## GENERAL COMMENTS

**Iowa Onsite Waste Water Association (IOWWA)**

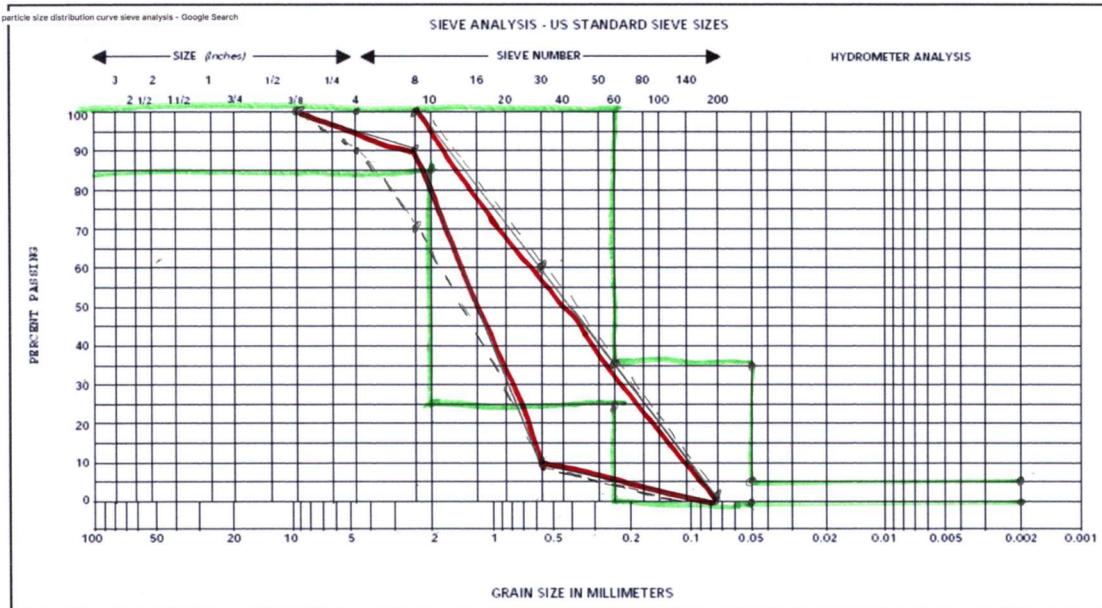
What does clean mean? Free of Debris? Washed?

Is "concrete sand" different than Iowa DOT standard for Concrete sand?

Seems confusing to have a different sand for mound than for sand filters. Especially if mound sand isn't required to be washed just clean.

- To save on language and the amount of words why not just reference IADOT standard 4110. All the sand quarries know DOT standard 4110. Below is the graph showing the ranges for mound sand, sand filter sand and dot 4110 sand.

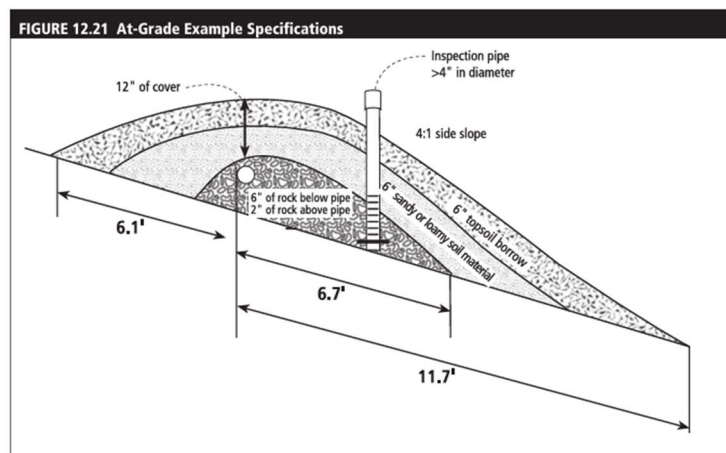
Letter a of this section allows for chamber and eps aggregate as well as gravel.

The tables are in 69.5(1) **"g"**(1)

k. One foot of loamy cover material shall be installed over the rock bed. Cover shall extend at least five feet from the ends of the ~~rock~~ at-grade system bed and be sloped to divert surface water. Side slopes shall not be steeper than 3:1 slope; however, a 4:1 slope is preferred. The upper six inches of the loamy soil cover must be topsoil borrow. Topsoil borrow must be of a quality that provides a good vegetative cover on the at-grade system.
